RE: Field Issue of over notched and holes bored closer than 2" together on floor joists for Lot #18 Units A and B Osage – 2017 and 2015 SW Osage Dr. Lee's Summit, MO 64082 – Permit # PRRES20213954

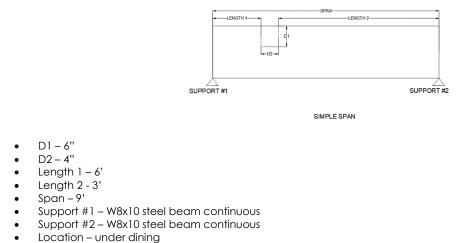
Over notched floor joist for DWV:

Loading -

• Dead = 15 psf @ 16" oc

• Live = 40 psf @ 16" oc

Option 1:

Add additional support to existing 2x10 notched floor joist. Sister Douglas Fir Larch #2 2x10 joist for 6' length with 4 fasteners per linear ft in "W" pattern with 2-1/2" structural screws or 10D nails to existing notched floor joist.

Notch sistered floor joist in compliance with 2018 IRC: Max width: D/3 = 3.08" Max depth D/6= 1.54" Located in edge third of floor joist span

Option 2:

Remove plumbing and header off floor joist near notch as shown in image below:
